TOWN OF PLAINFIELD PLAN COMMISSION REPORT

CASE NO.: [RZ-24-057](#)

REQUESTED ACTIONS: Rezone 0.562 acres from AG: Agriculture to R-3: Medium Density Residential

LOCATION: 8313 East County Road 300 S

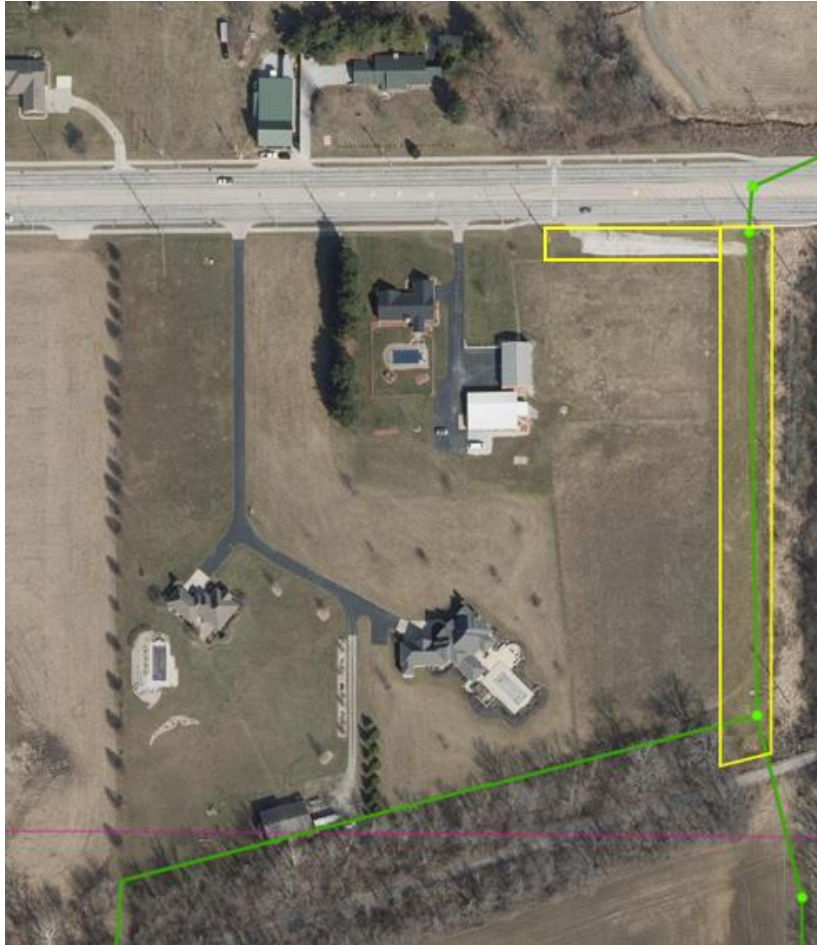
With the parcel split and expected ownership change, the splitting of utility services will be needed in order to service the new physical address. DPW has confirmed that a double meter was previously installed in anticipation of this. It is believed that the existing sanitary lateral will also accommodate this change, though additional investigation may be needed.

During Staff's preliminary review, no evidence was found of a sanitary sewer easement that was anticipated to get platted as part of a previously considered development plan. Staff recommends that the Secondary Plat be amended to include for a Sanitary Sewer Easement to address this finding. The area highlighted in yellow approximates the area of the sewer and the constructed access from the public right-of-way.
